Form 3160-3 (June 2015) UNITED STATES			APPROVE o. 1004-01 inuary 31, 2	37		
DEPARTMENT OF THE INT BUREAU OF LAND MANAC				5. Lease Serial No. NMNM126494		
APPLICATION FOR PERMIT TO DRI	ILL OR I	REENTER		6. If Indian, Allotee or Tribe Name		
1a. Type of work: Image: Constraint of the second seco	NTER			7. If Unit or CA Agreement, Name and No.		
1b. Type of Well: Image: Completion: Oil Well Gas Well Othe 1c. Type of Completion: Hydraulic Fracturing Image: Single	r le Zone	Multiple Zone		8. Lease Name and Well No. TWEETY BIRD 17 FED COM		
				502H	334562

PECOS DISTRICT DRILLING CONDITIONS OF APPROVAL

OPERATOR'S NAME:	EOG RESOURCES INCORPORATED
WELL NAME & NO.:	TWEETY BIRD 17 FED COM 502H
SURFACE HOLE FOOTAGE:	2246'/N & 1079'/W
BOTTOM HOLE FOOTAGE	100'/N & 988'/W
LOCATION:	Section 17, T.23 S., R.33 E., NMP
COUNTY:	Lea County, New Mexico

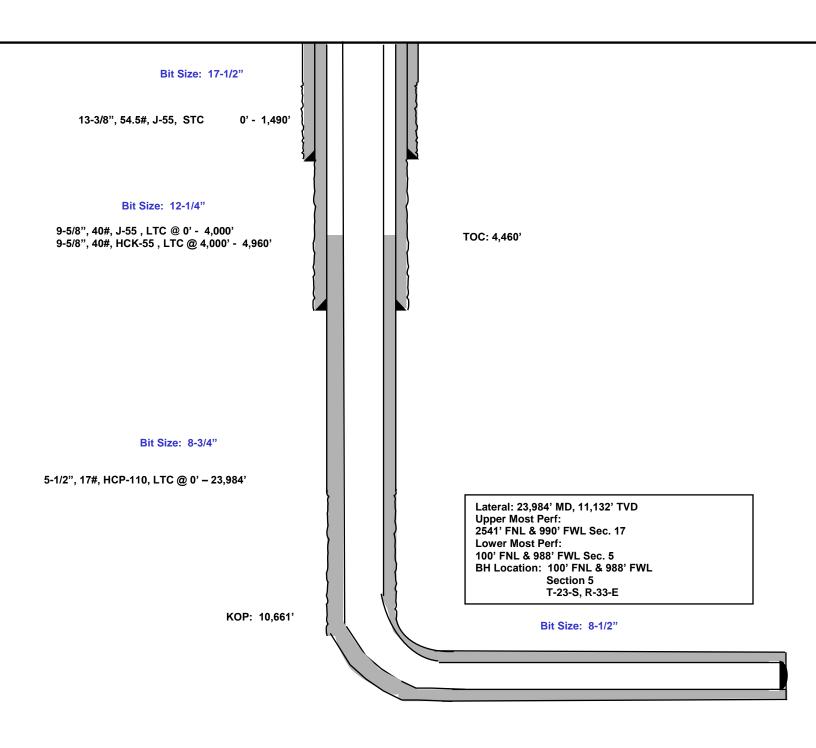
- a. Wellhead shall be installed by manufacturer's representatives, submit documentation with subsequent sundry.
 - b. If the welding is performed by a third party, the manufacturer's representative shall monitor the temperature to verify that it does not exceed the maximum temperature of the seal.
